MARQUETTE CITY PLANNING COMMISSION
Tuesday, September 02, 2025, at 6:00 p.m.
Commission Chambers at City Hall – 300 W. Baraga Ave.

TO: Planning Commission
FROM: Andrea Landers, Zoning Official
DATE: August 28, 2025
SUBJECT: 07-SPR-09-25 (01-PUD-03-25) – Final Site Plan Review for W. Magnetic St
(Portion of PIN: 0410681)

VERIDEA GROUP
MARQUETTE GENERAL HOSPITAL SITE RE-DEVELOPMENT

| | | | | | SHEET NO. 10 | DWG. NO. C-03.1 | |

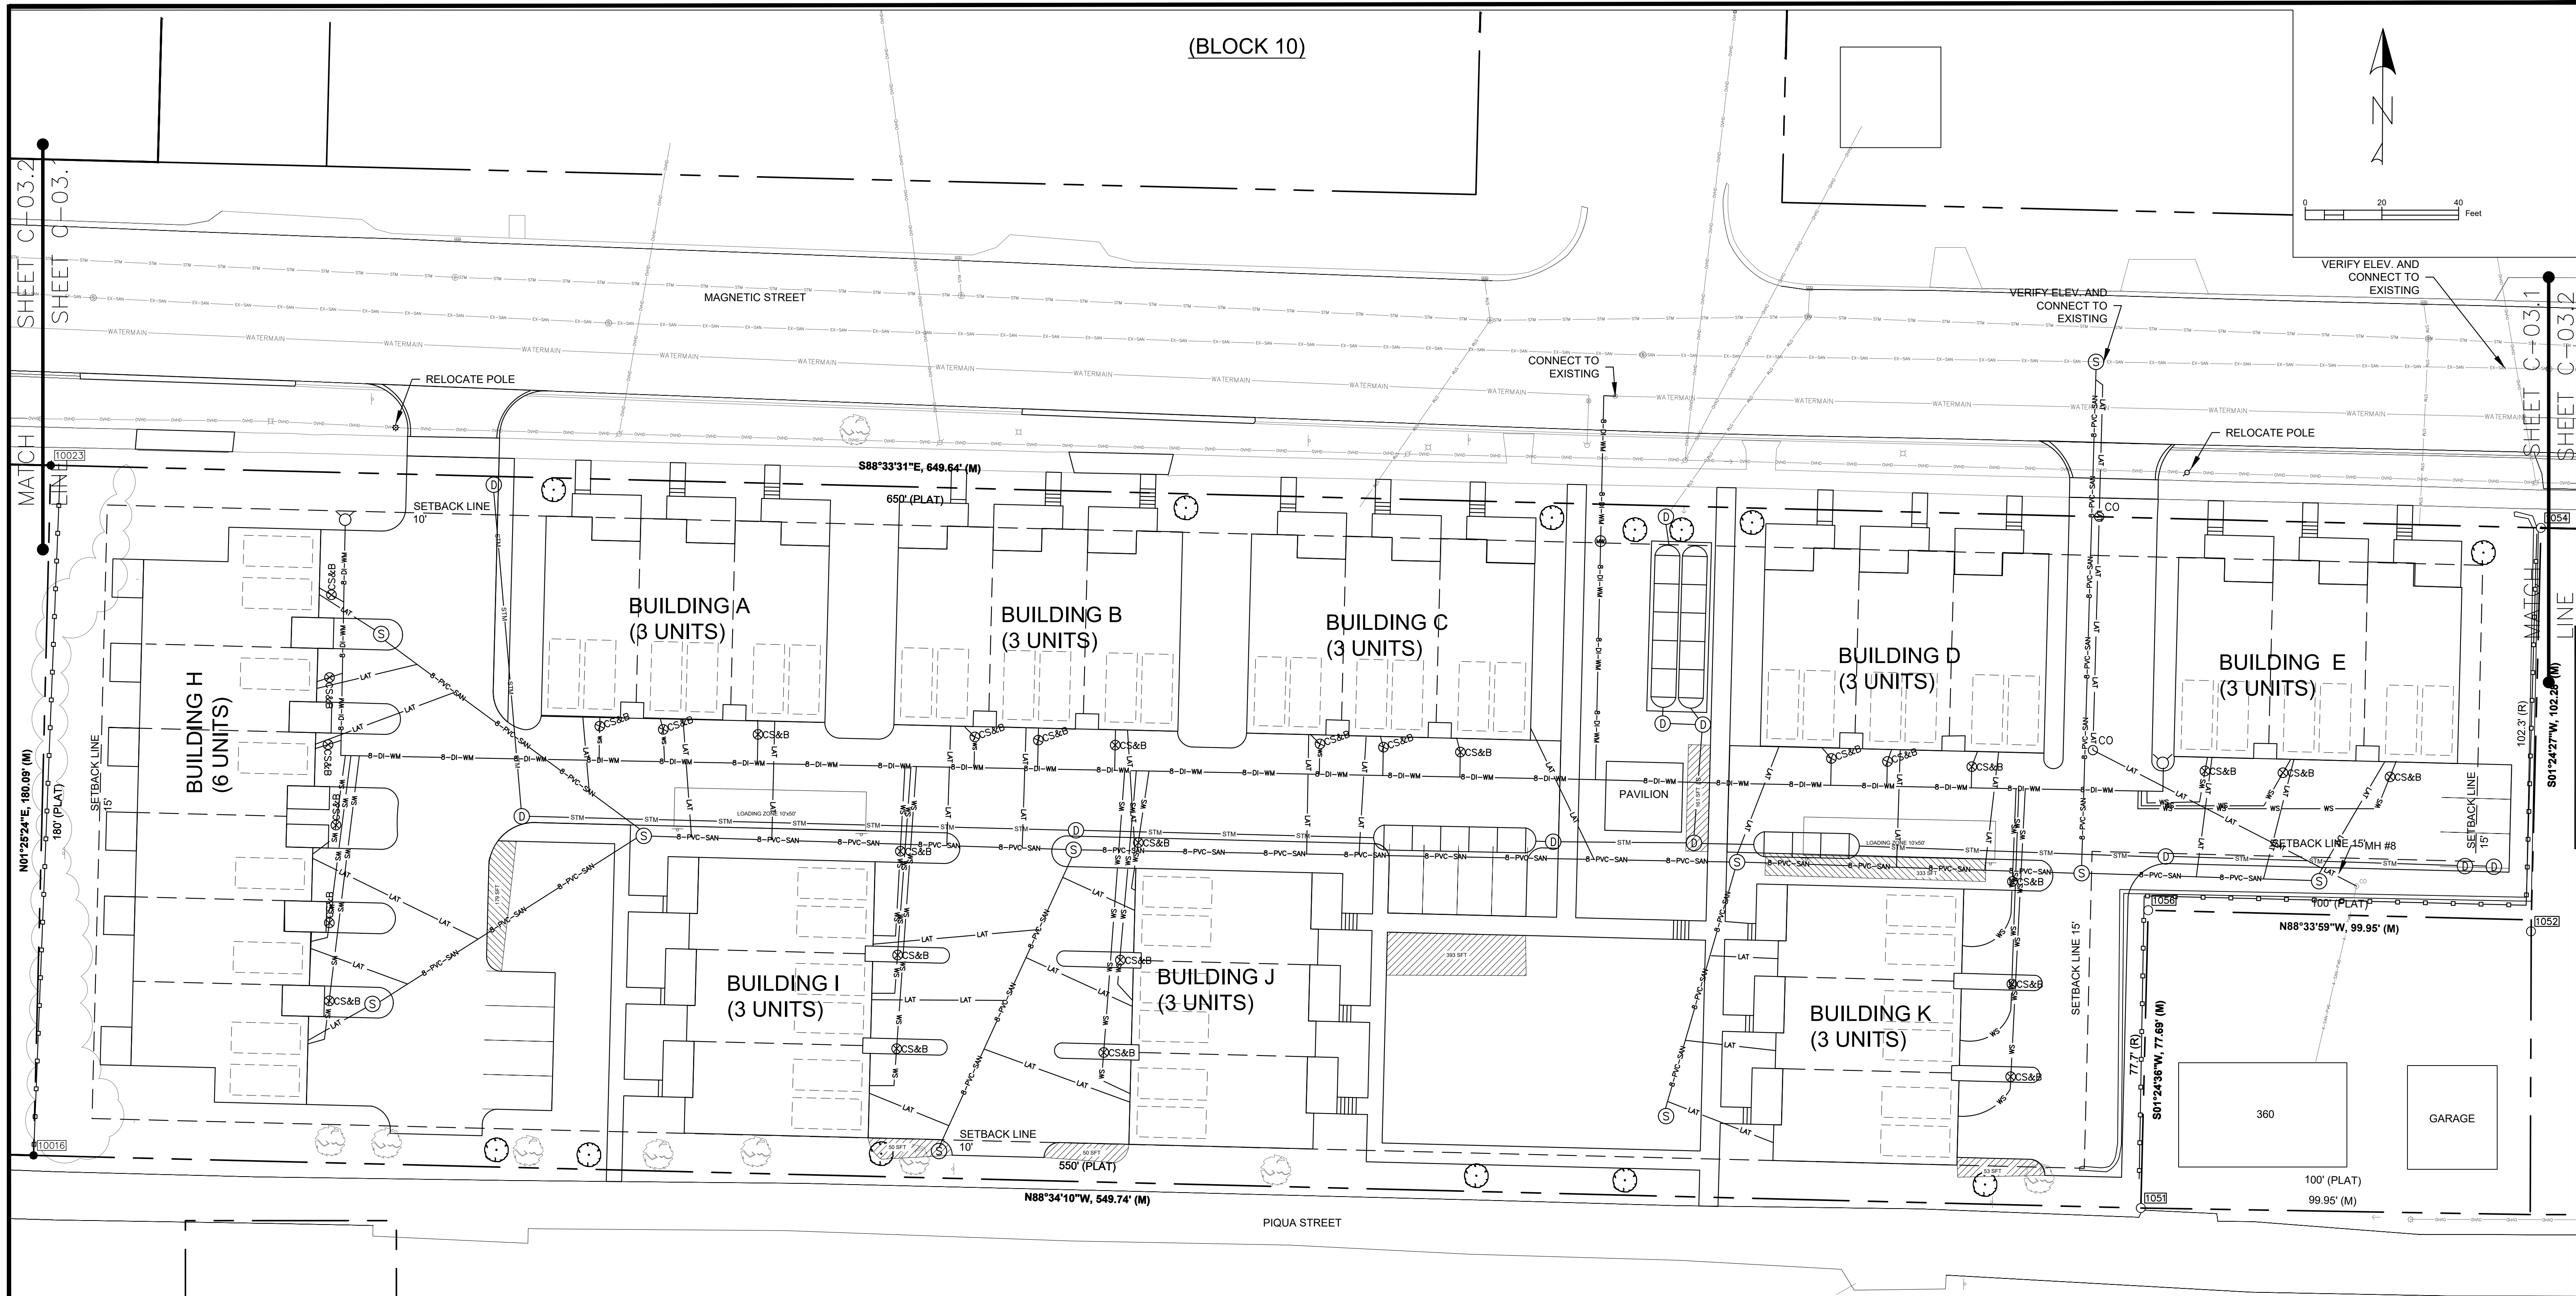
- Valves must be placed on either side of the water meter pits. **Valves will be add See sheets C-03.1 & C-03.2.**
- Manholes must be placed at right of way on sanitary sewer mains. **Manhole will be add See sheets C-03.1 & C-03.2.**

Sheet C-04.1

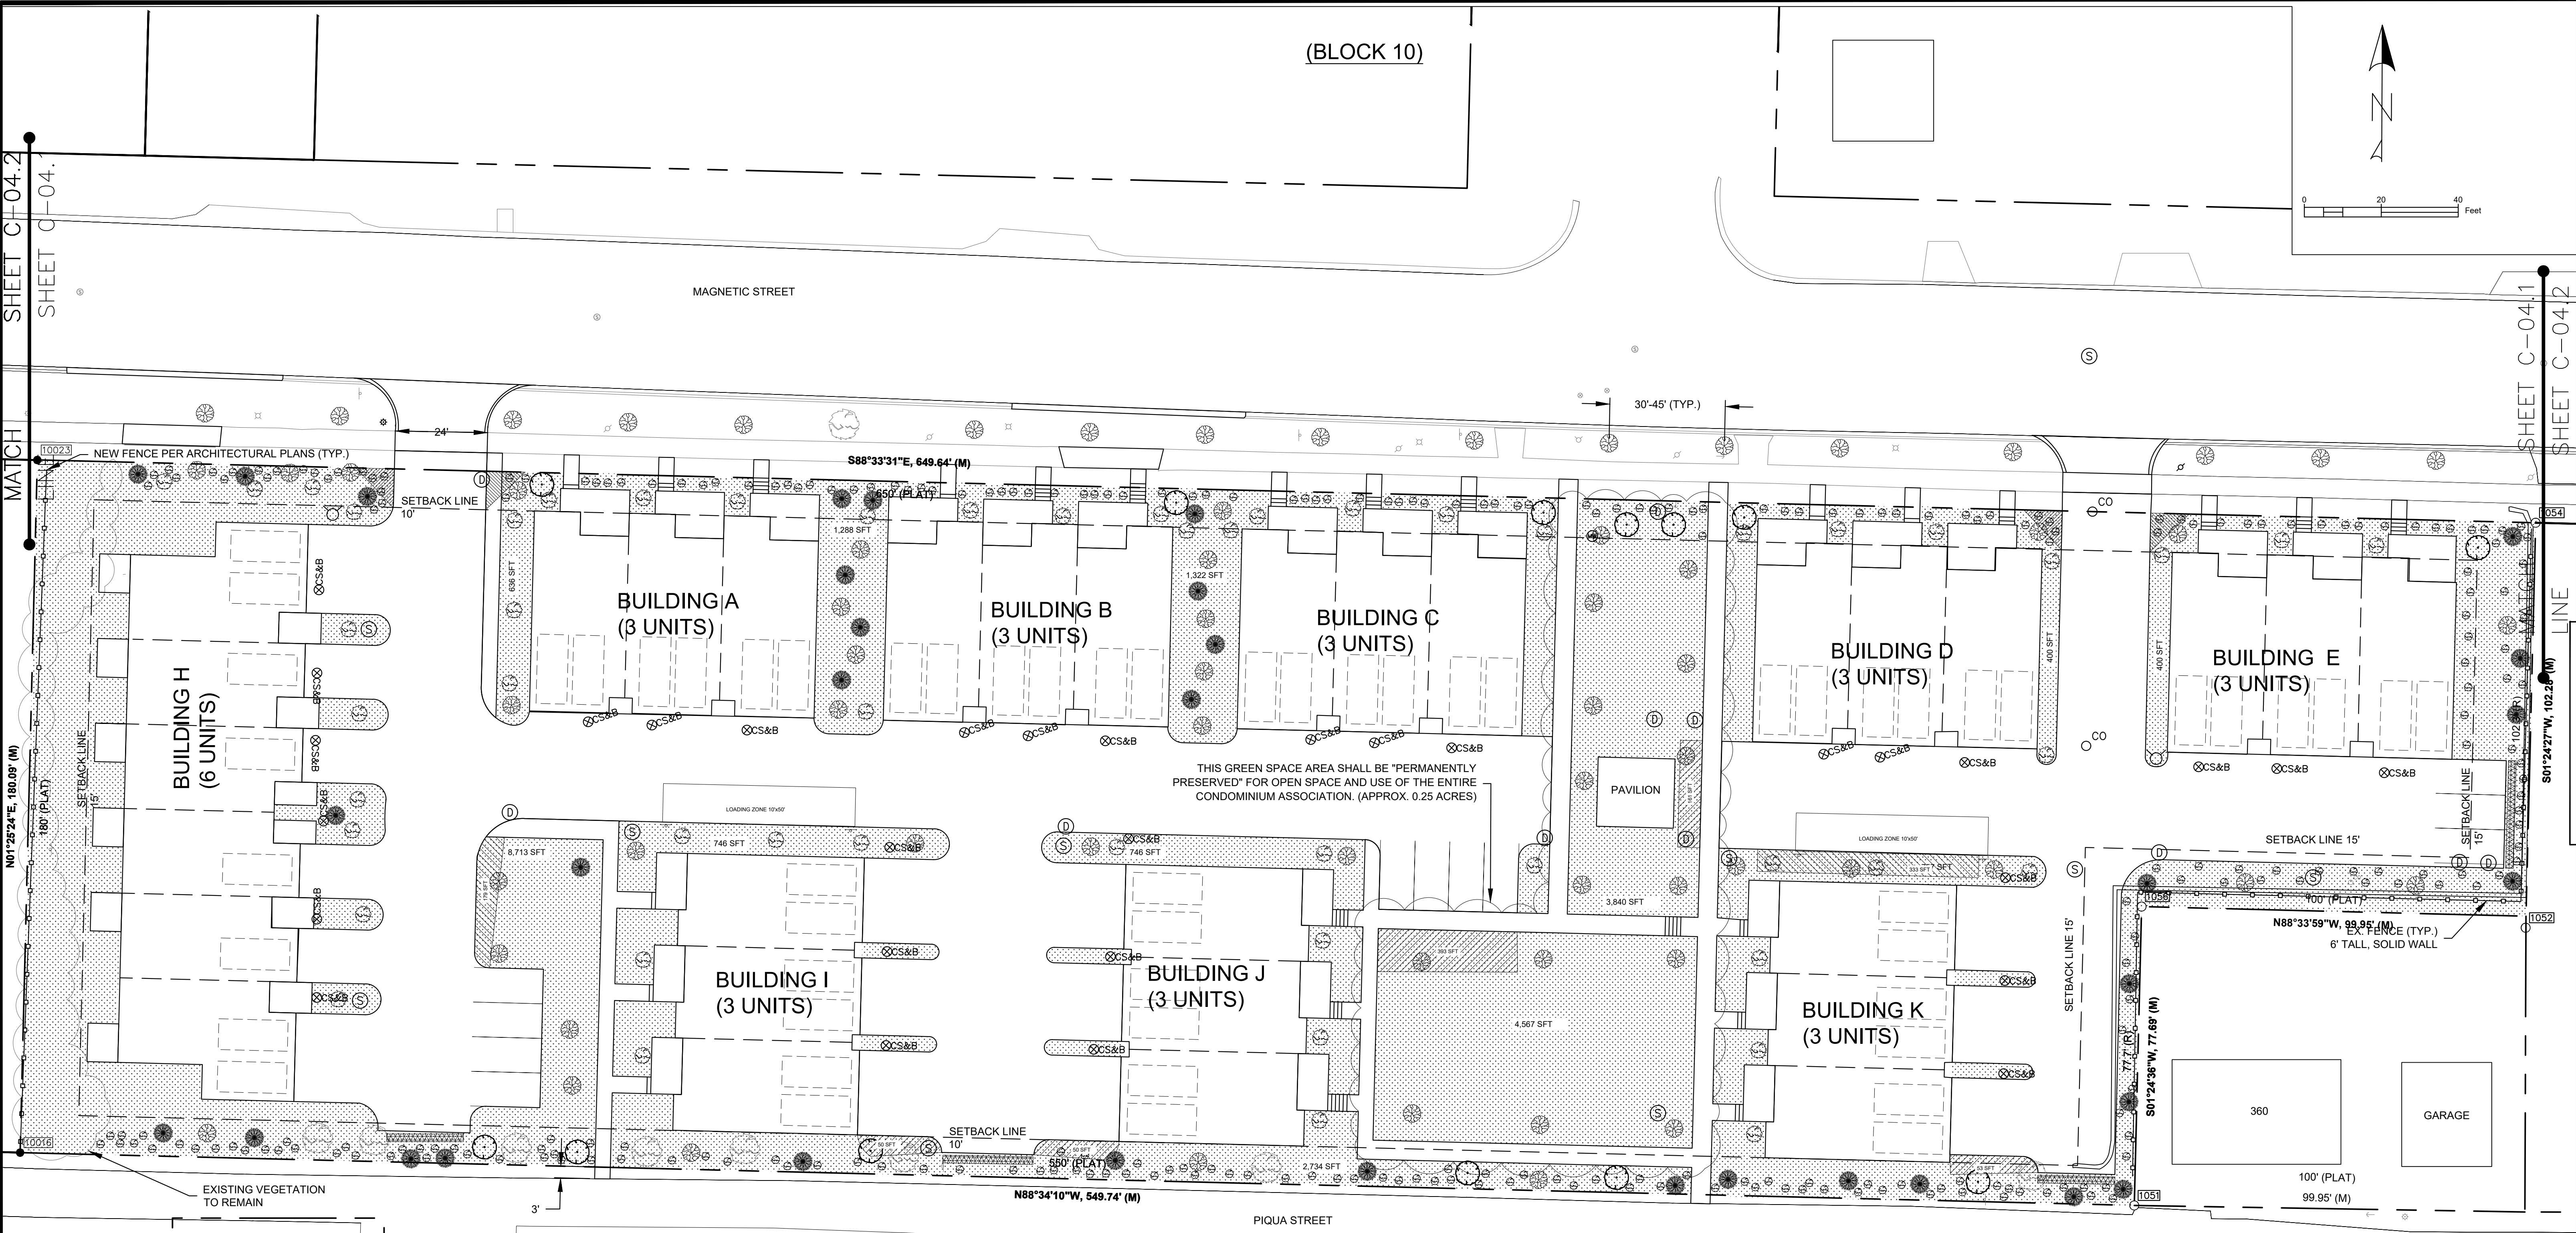
1. The parking lot to the south of Building E abuts a residential zoning district to the east and to the south. Please provide how you propose to meet **Section 54.905(I)** of the LDC. You have a note that states existing fence but not what type and height of the fence.
Plans will be revised to show fence height and type (6' height solid fencing). Existing fencing shall be removed and replaced in accordance with 54.905(I) and architectural sheet LP-100 and LP-101.
